Product Change Notification

113883 - 01

Change Notification #: 113883 - 01
Change Title: Intel® Server Board S2600WTT and S2600WT2
PCN 113883-01, Product Design
Update BIOS/ME/BMC/FRUSDR Firmware,
update the IO connector and remove the
resistor
Reason for Revision: Update TA numbers.

Date of Publication: August 27, 2015

Figure 1

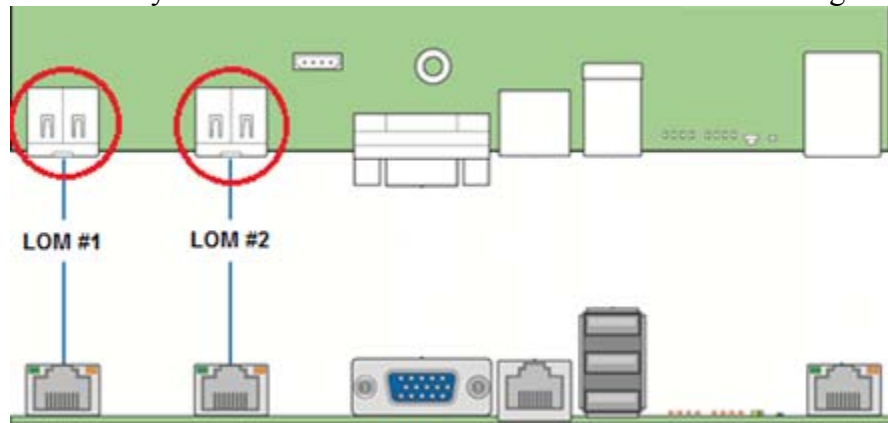
7. Update the RJ45 connectors for onboard LAN ports 1 and 2 to improve the LAN cable connectivity. The locations of the IO connector are shown as Figure 1:
